Bayside Planning Panel

Item No	5.2
Application Type	Section 96(1A)
Application Number	DA-2016/247/A
Lodgement Date	7 February 2017
Property	3 Holland Avenue, Rockdale NSW 2216
Owner	Mr Warren Peter Chan
Applicant	Green Square Design Pty Ltd
Proposal	Modifications to alterations and additions to dwelling house, including rebuilding of all existing external walls, minor adjustments to external walls, changes to internal layout, increase parapet height, alterations to windows and relocation of stair to roof terrace
No. of Submissions	11
Cost of Development	\$400,000
Report by	Luis Melim, Manager Development Services

Planning Assessment Report

1. Shadows June 22 1:200

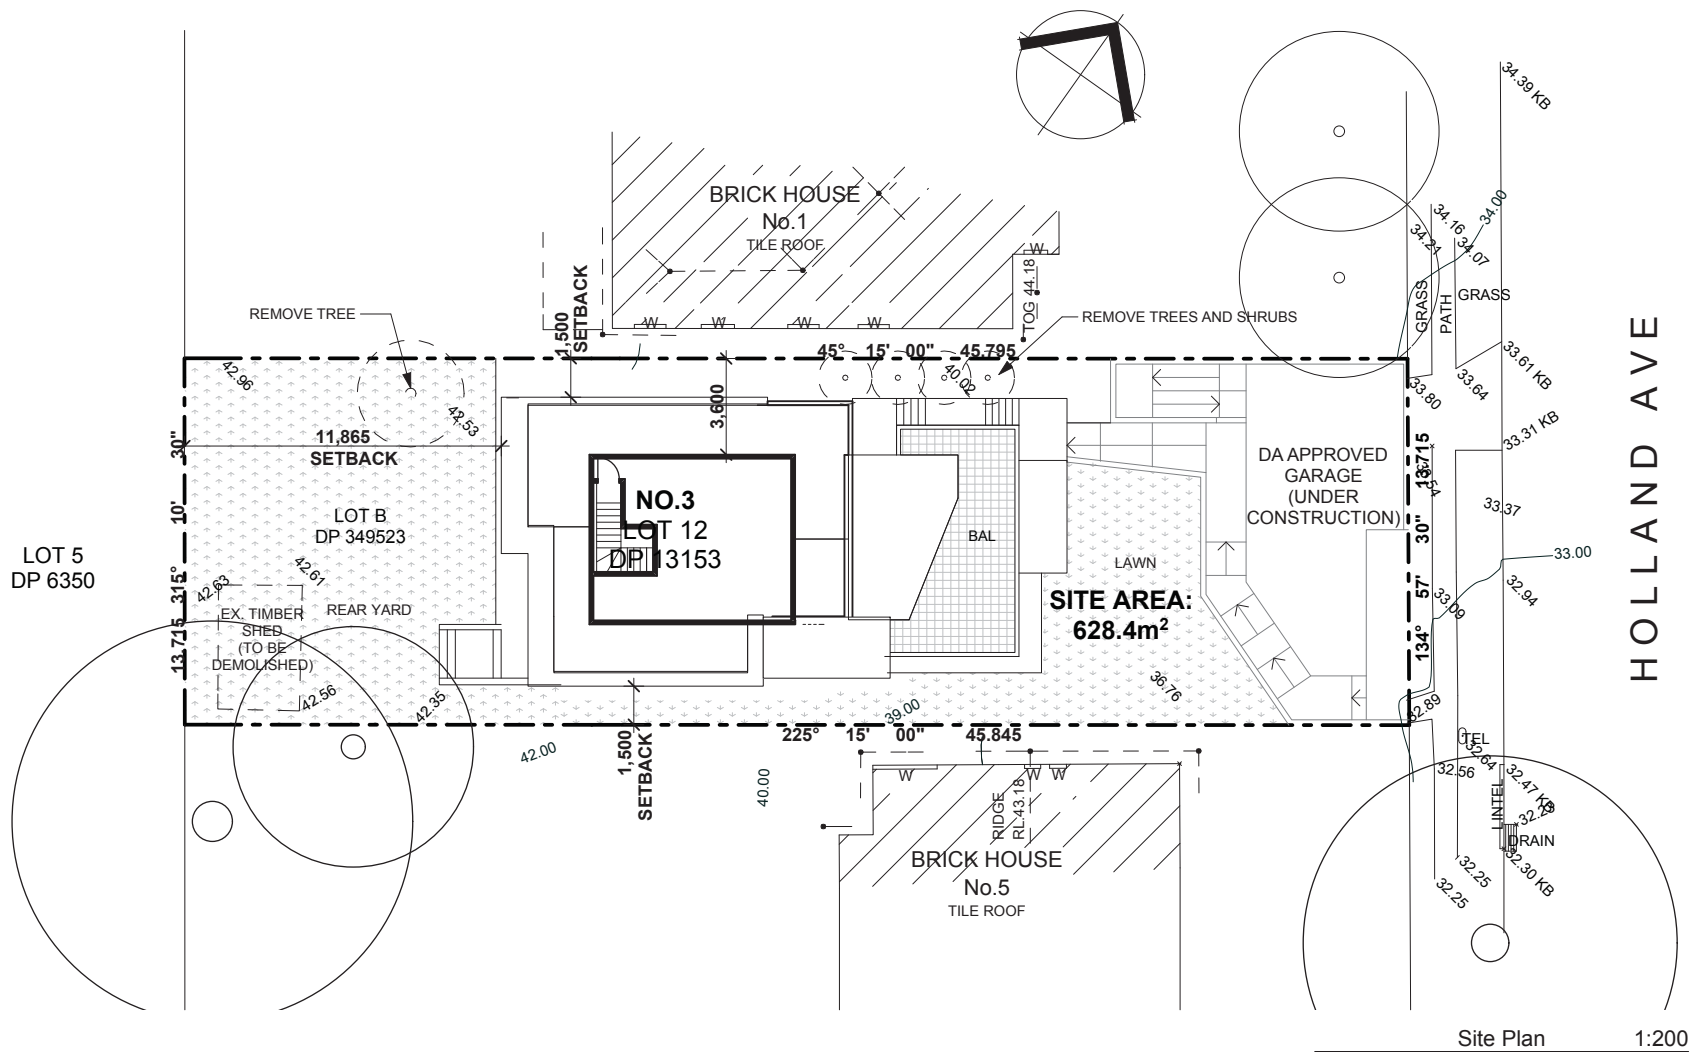
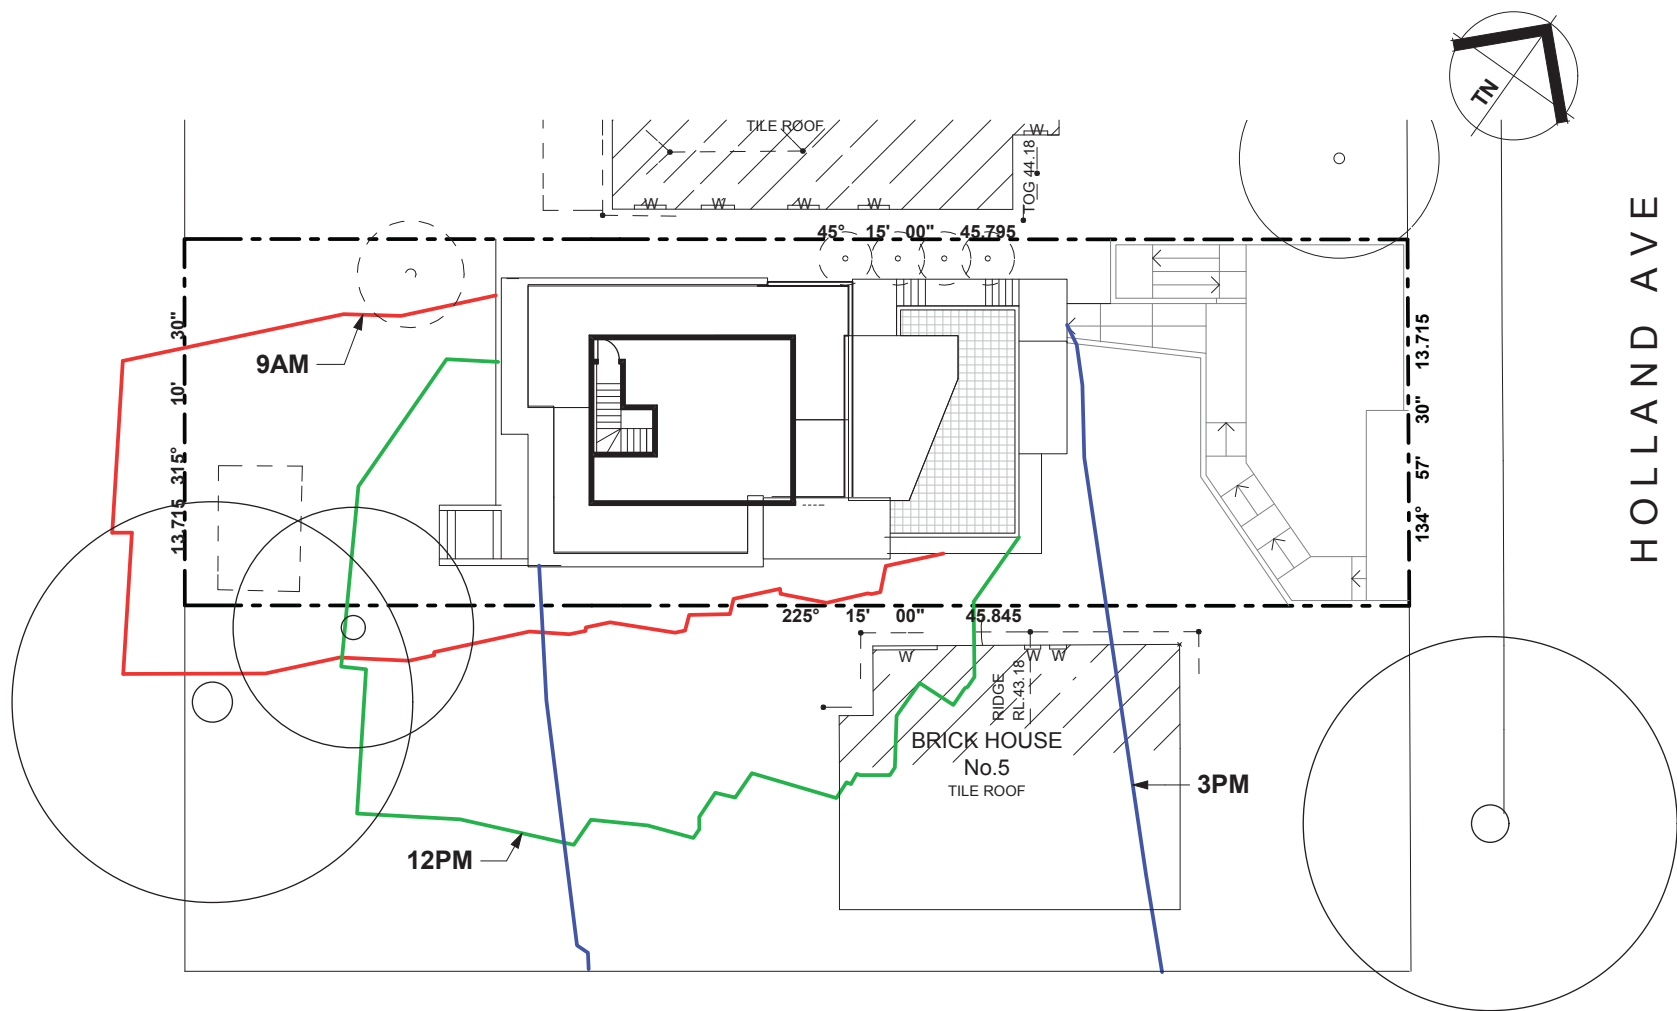
The proposed height increase on the first floor level parapet by 100mm will not generate excessive impacts onto the adjoining properties in terms of overshadowing. The applicant was requested to submit additional shadow diagrams for the proposed modifications. These shadow diagrams have formed part of this assessment. The shadow diagrams show that the proposed modifications will have negligible impacts onto the adjoining property to the south.

Issue 2: The change in side setbacks measured from the first floor level will also create additional overshadowing impacts and the increase in building height by 100mm will create overshadowing impacts

Comment: The changes to setback will not generate any significant overshadowing impacts to warrant refusal of this proposal. The change in setbacks remain compliant with Council's setback controls. The increase in building height by 100mm at the rear portion of the first floor level is not assessed as significant and the increase will have no discernible impacts onto the adjoining property to the south in terms of over-shadowing. Shadow diagrams were received as additional information and have been assessed. The changes to setback remain compliant with the numerical controls. Refer to part 4.4.2 of this report.
